CITY OF ALBUQUERQUE

RE: **Lot 3 Block 6 Unser Cliffs SAD 227**
7909 Victoria NW
Grading and Drainage Plan
Engineers Stamp Date 7/18/18 (E10D048)
Pad Certification Date 8/18/18

| ENGINEER'S SEAL | 7909 VICTORIA DRIVE | DRAWN BY DEM |
| | GRADING AND DRAINAGE PLAN | DATE 7-17-18 |

| 7/18/18 | | SHEET # C1 |

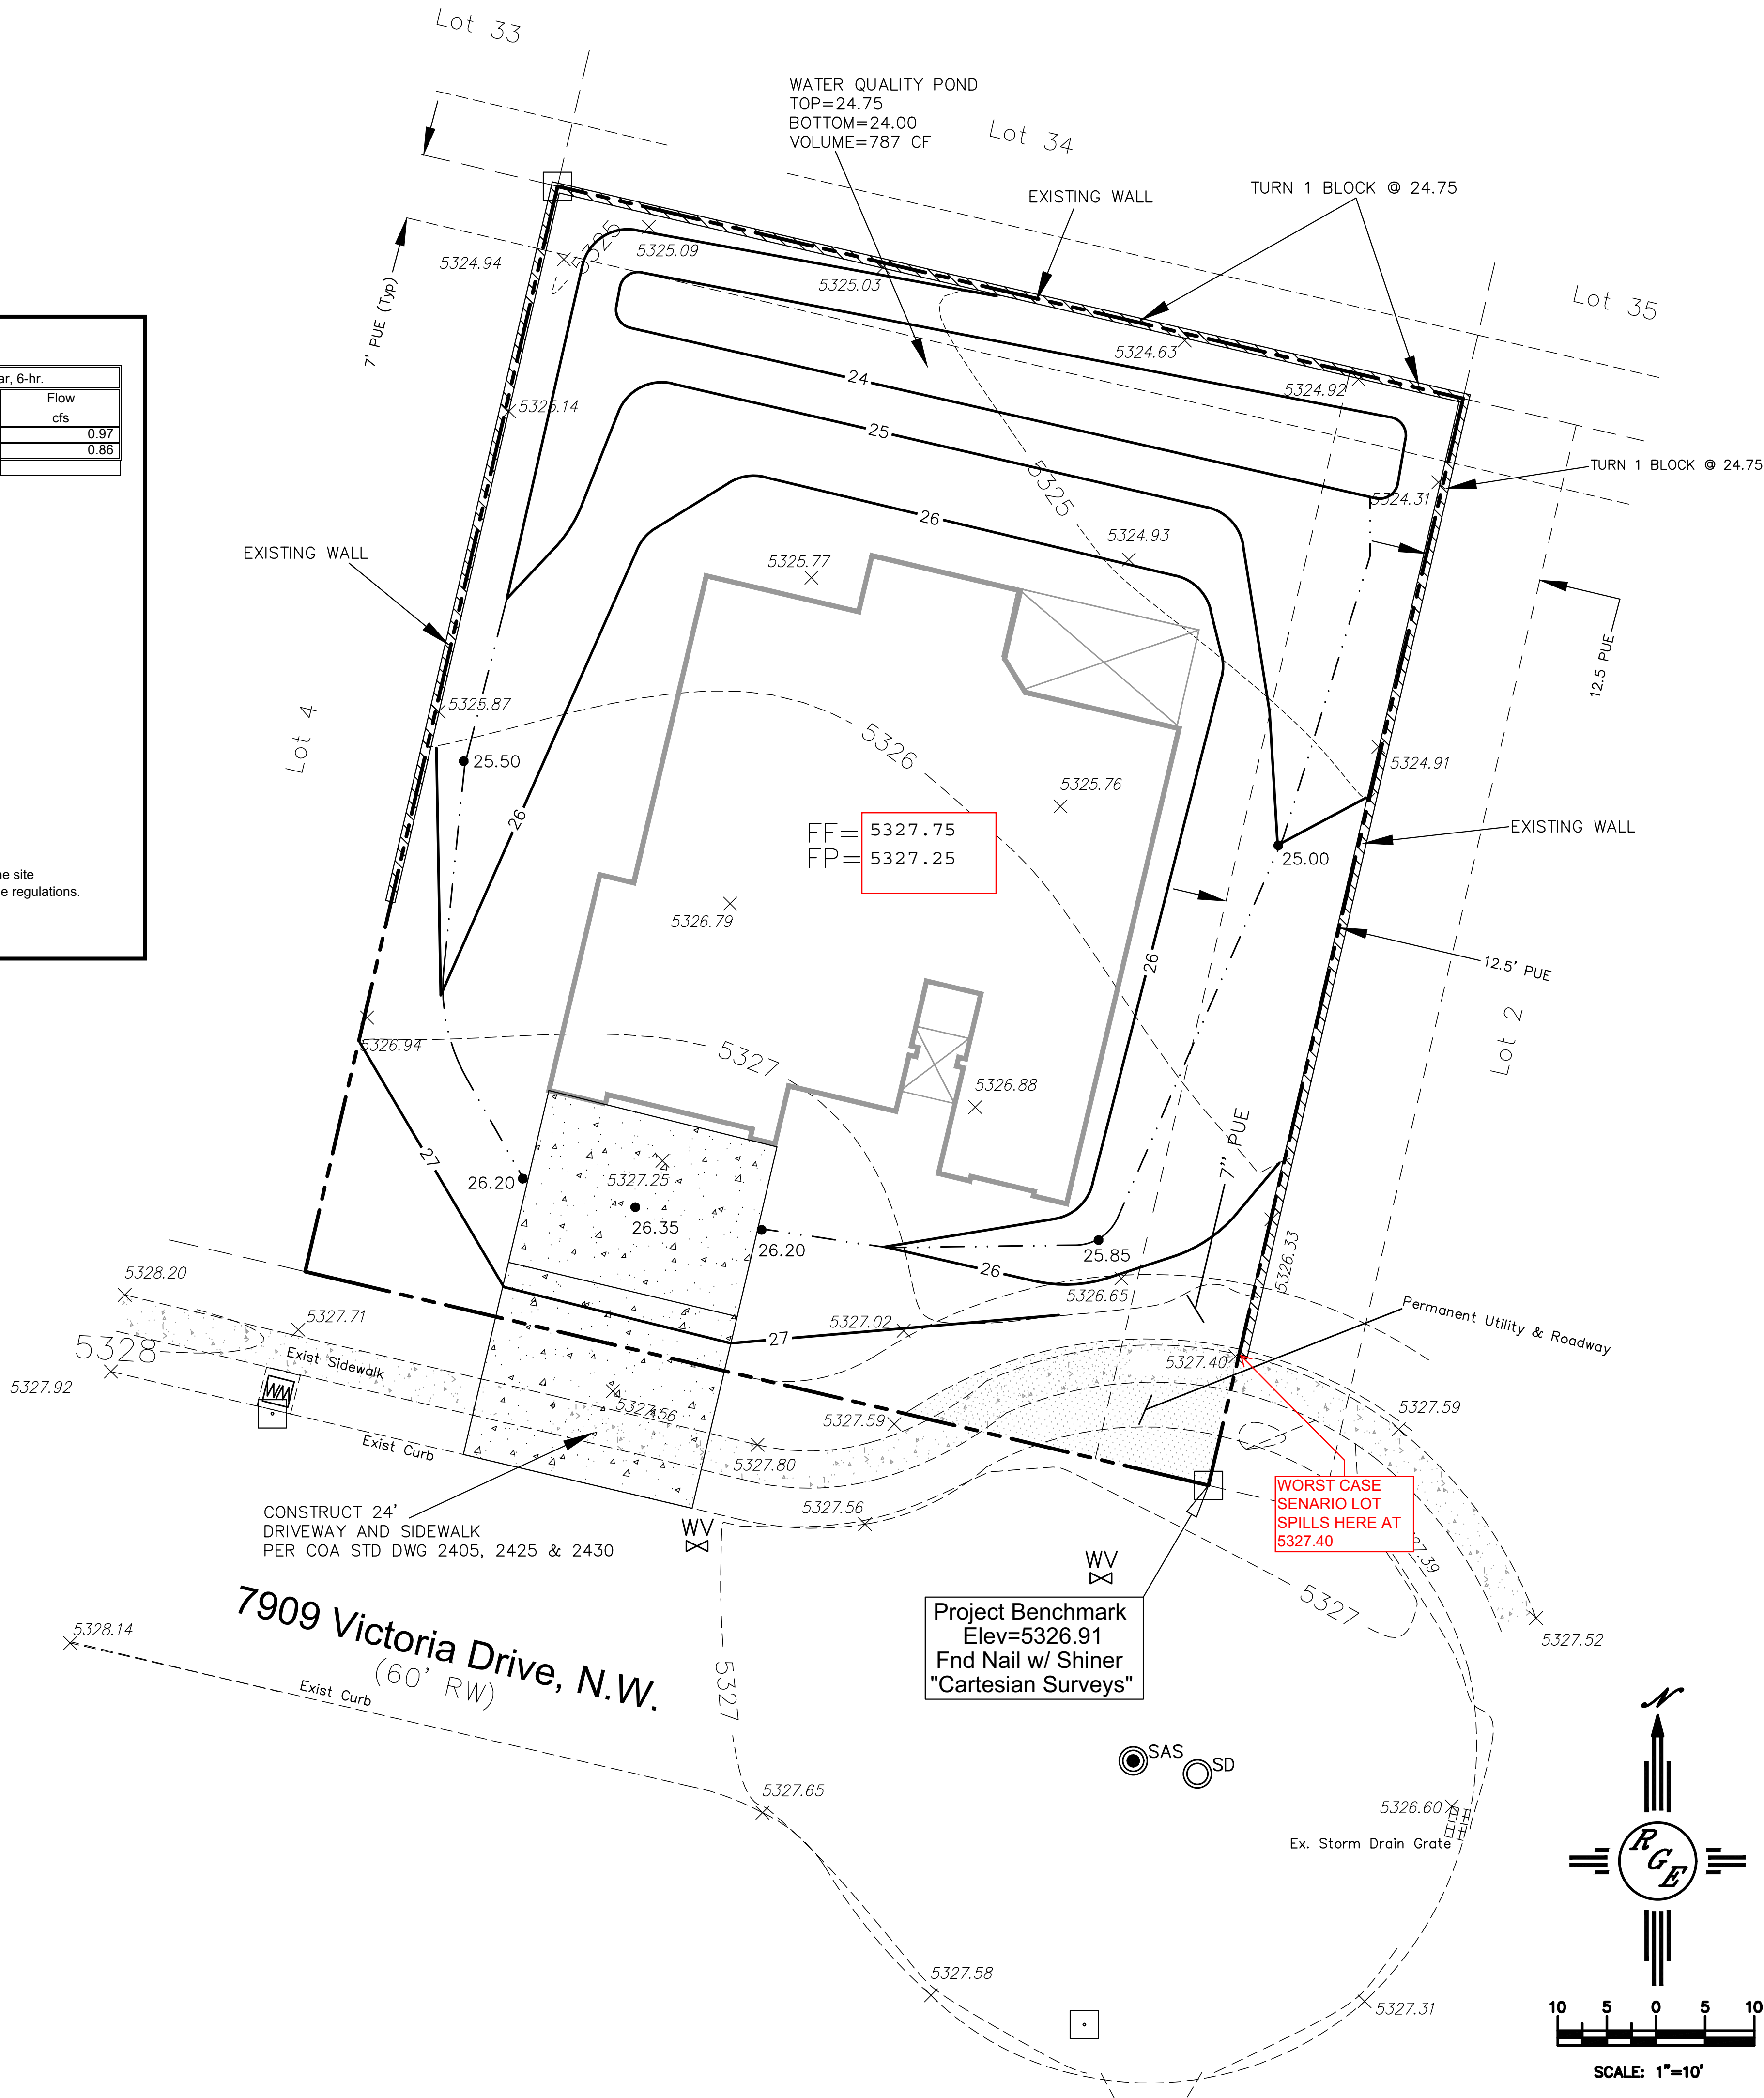
Based upon the information provided in your submittal received 8/9/18, this plan is approved for Building Permit.

Reiterate to the Owner/Contractor that a separate permit for a garden/retaining wall must be obtained, with the approved G&D plan dated 7/18/18.

Prior to Certificate of Occupancy release, Engineer Certification per the DPM checklist of this plan will be required.
